**NARAMA WEST MODIFICATION**

# **RESPONSE TO SUBMISSIONS**

**Xstrata Coal Pty Limited**

June 2013

**Figure 1 –  $PPV_g$  vs Distance for various target vibration limits and a 1.6 exponent**

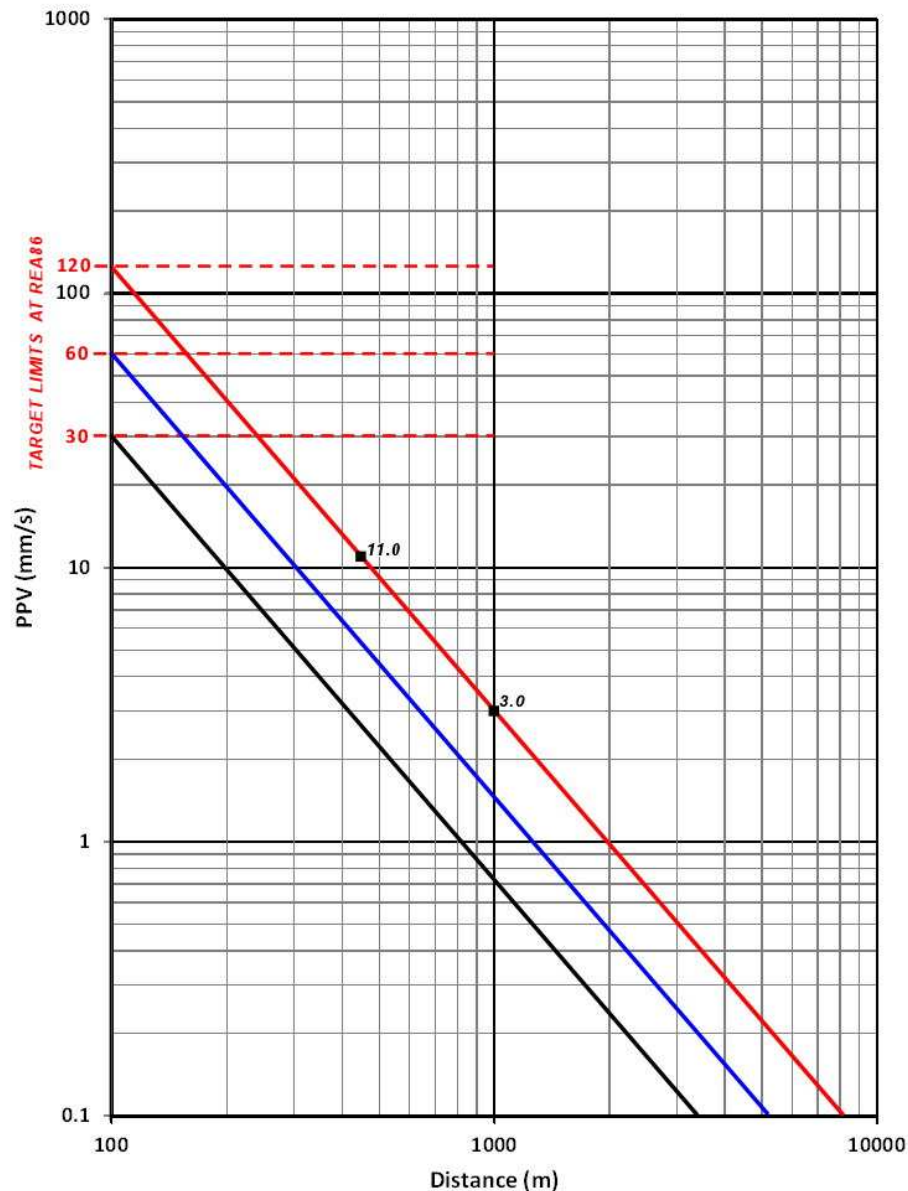
- Editorial matter. OEH refers to Figure 1 of the letter from Terrock Consulting Engineers (dated 19 February 2013). Further information is required by the proponent to clarify the source of the data presented in this figure.*

- Editorial matter. OEH refers to Figure 1 of the letter from Terrock Consulting Engineers (dated 19 February 2013). Further information is required by the proponent to clarify the source of the data presented in this figure.

The relationship between  $PPV_g$  and distance is shown in **Figure 1** on log-log array so it is represented as straight lines. The current approved limit is 30 mm/s with a proposal to incrementally increase the target limit to 120 mm/s (with a possible ultimate target of 175 mm/s). 175 mm/s is the target limit indicated to result in stress of about 35% of the ultimate tensile failure strain. The target limits apply at the Grinding Grooves irrespective of distance, with the blast design based on the Site Law to limit ground vibration. The vibration levels decrease with distance as shown in **Figure 1**.

Two points can be made with reference to **Figure 1**. Firstly, in order to comply with a target limit, the scale of blasting may have to be reduced by means of smaller diameter blast holes, decked explosive charges and smaller blasts. At some distance from REA 86, standard blasting practice will comply with the target level and beyond this standard blasting practice will result in ever decreasing vibration levels.
